Searock Apparels Ltd

12.NOVEMBER.2014

Structural Inspection Report

Observations & Actions

Cracks on Beams of 5th floor roof slab

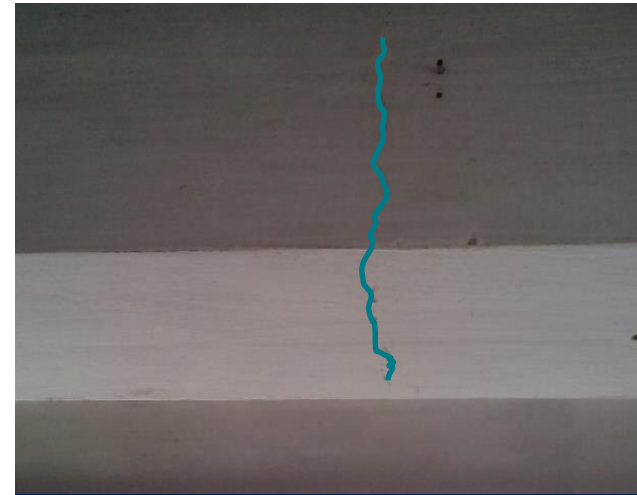
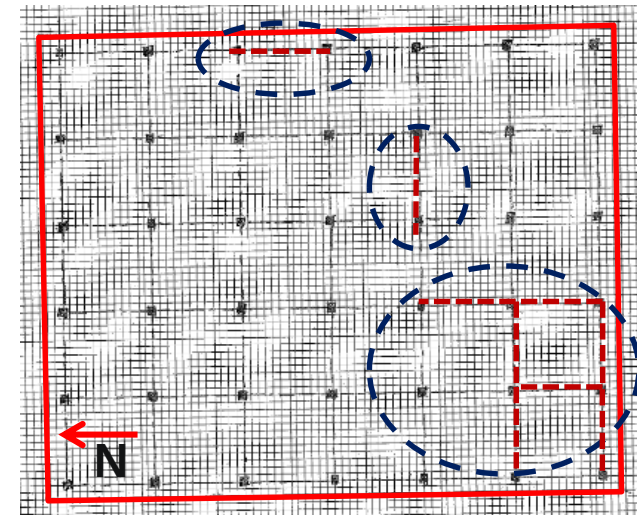
Several Cracks are observed on various slabs and beams of 5th and 6th floor. Which is Suspected as flexural cracks.

Item No.	Observation	Recommended Action Plan	Recommended Timeline
7	Cracks in several Beams and Slabs	Building engineer to check all cracks either their structural or not. If it is structural then repair all cracks. Only plaster is not acceptable.	6 – weeks
8	Inconsistencies between Record Information and existing structure	The building engineer to survey the actual conditions and produce the As-build drawings as early as possible.	6 – weeks
9	Inconsistencies between Record Information and existing structure	Check the foundation system. Building Engineer to provide evidence of as constructed foundation type by digging trial pit.	6 – weeks
10	Water Ingress at Roof Level.	Provide a proper water proofing layer or Membrane on the roof floor.	6 – weeks
11	Water Ingress at Roof Level.	Provide water proofing paint or layer on extended reinforcement. If no extension is necessary or planed then cut them all.	6 – weeks

Cracks on 6th floor roof slab

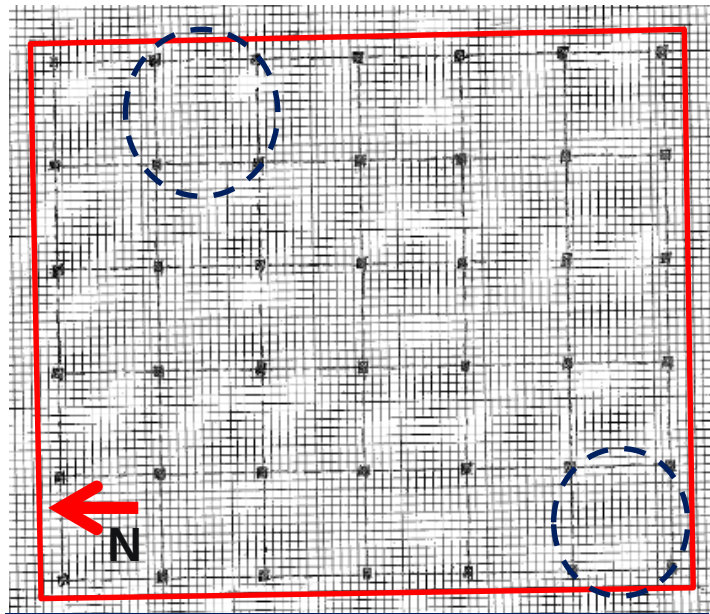
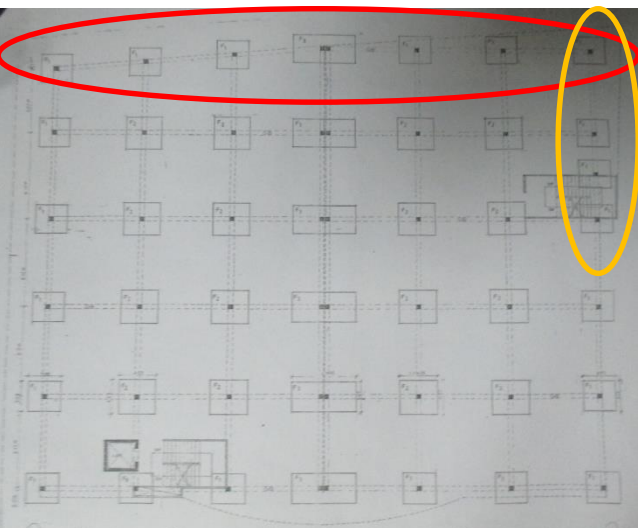
Crack appears on 5th floor roof slab on east side and 6th floor roof slab on south west corner of factory building.

Foundation Layout from structural drawing

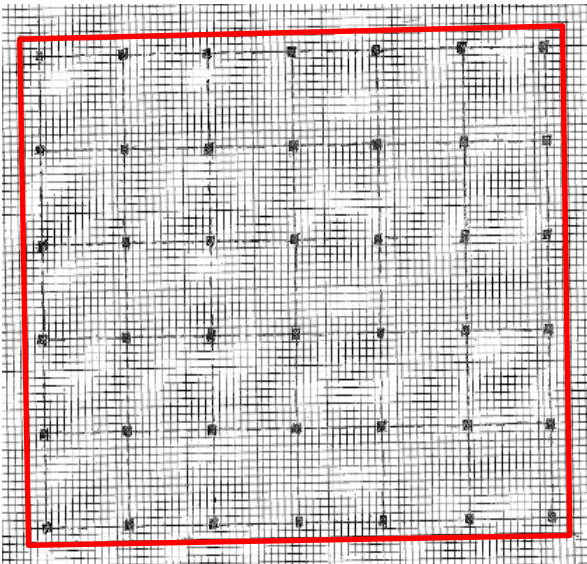
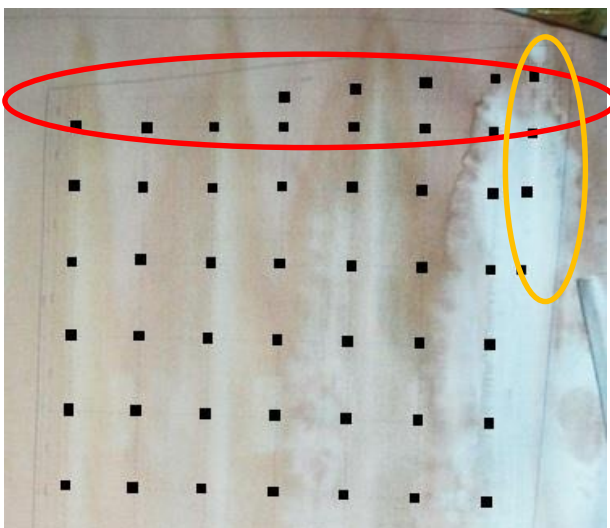
Foundation layout from structural drawing and Column layout from permit drawing are not matched with each other. Even actual column layout is different from both of them.

Inconsistencies between Record Information and existing structure

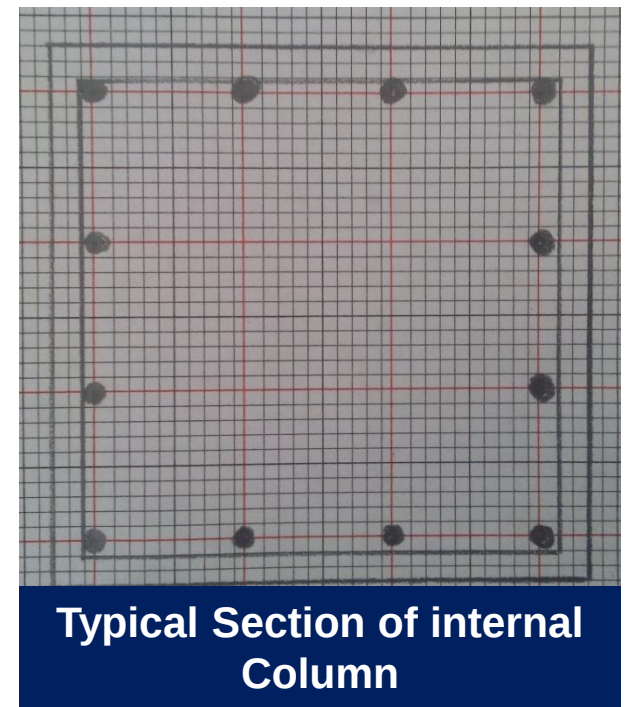
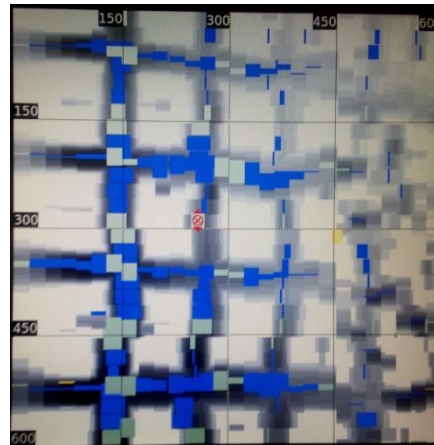
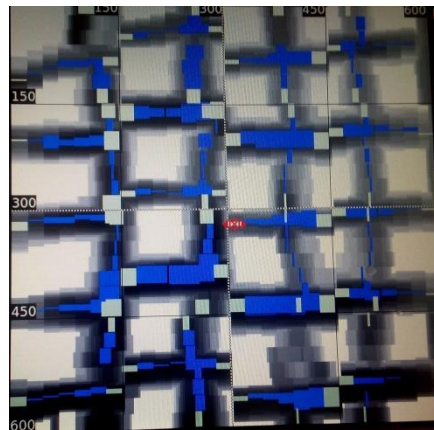
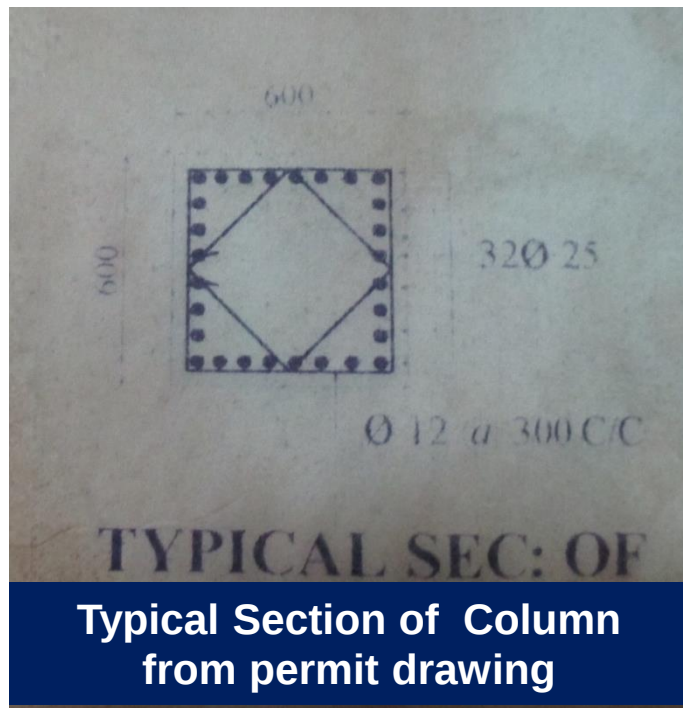
Permit Drawing and structural drawing shows that internal column is 600X 600mm with 32, 25mm bar. From Ferro Scan and exposed column at top Floor found that internal columns are 600x600mm with 12, 25mm bar and Edge and corner columns are 550x500mm with 4, 20mm + 8, 25mm bar.

Typical footing section from permit drawing

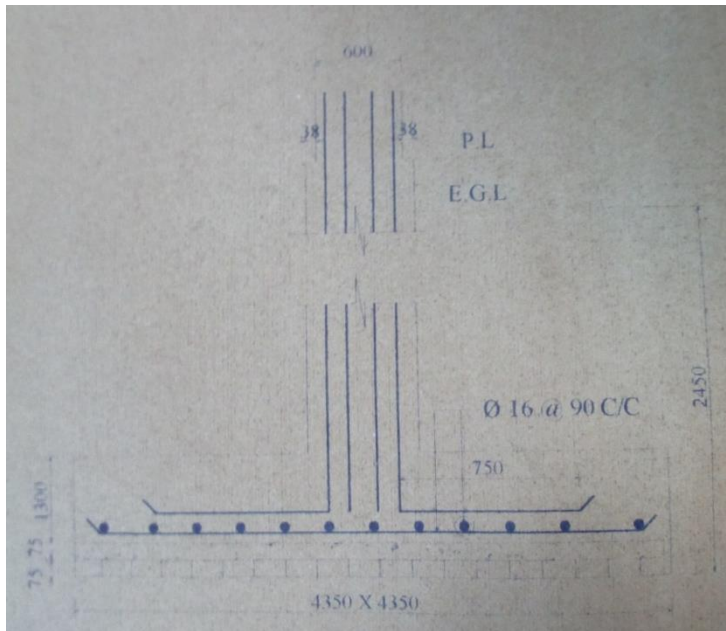
Soil Test Report Recommend that Isolated column footing at 12 ft depth below existing ground level. From Structural Drawing recommend isolated Column Footing at 8 ft depth below existing ground level.

Water Ingress at Roof Level

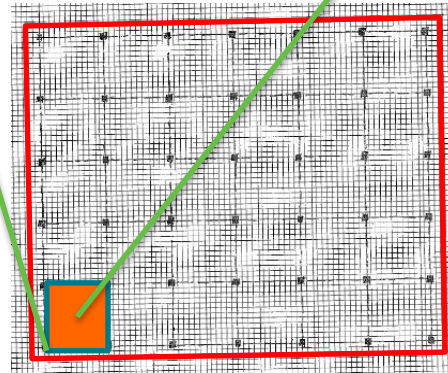
No waterproofing membrane was visible on the roof of the main factory building. This means that any cracks in the surface finishes on the roof will allow water to seep into the concrete slab beneath the finishes, and cause corrosion of the reinforcing steel.
